SERVICE BULLETIN

INTRODUCTION OF A NEW OIL DIPSTICK

FOR ROTAX® ENGINE TYPE 912 AND 914 (SERIES)

SB-912-040 R1

the following drawings should provide additional information:

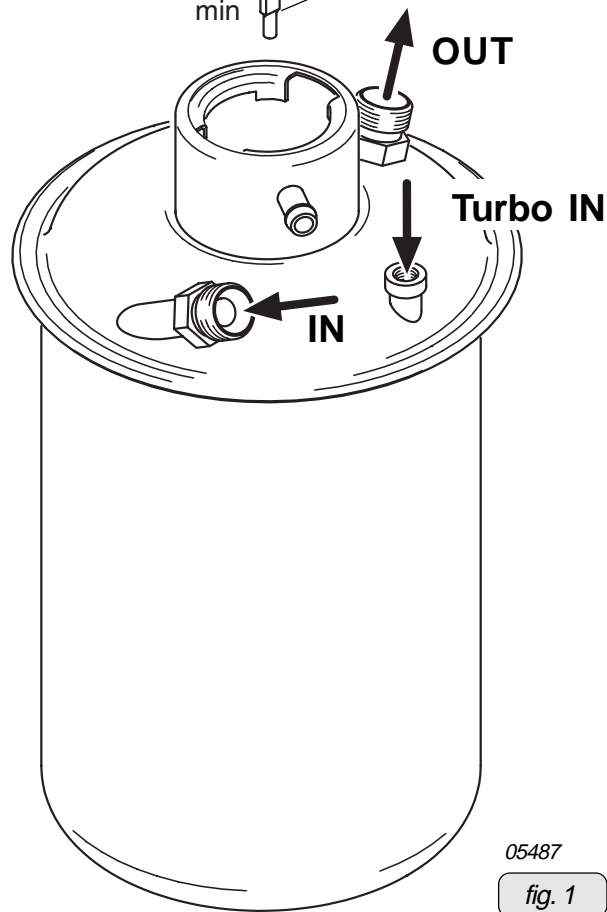
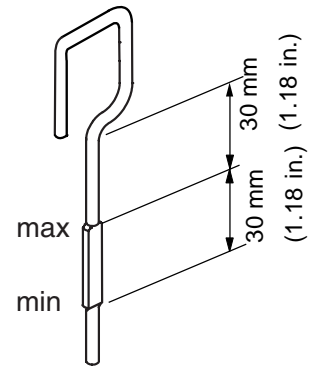
- Remove the oil dipstick part no. 956150 and replace by new oil dipstick part no. 956151.
- Inspect the oil level to be performed SI-27-1997 "Oil level check", current issue.
- Add oil if necessary.

◆ **NOTE:** By changing the oil dipstick, the minimum oil level is raised by approx. 40 mm (1.57 in.) and the height between the "min." and "max." level is reduced to 30 mm (1.18 in.) (approx.0,45 litre).
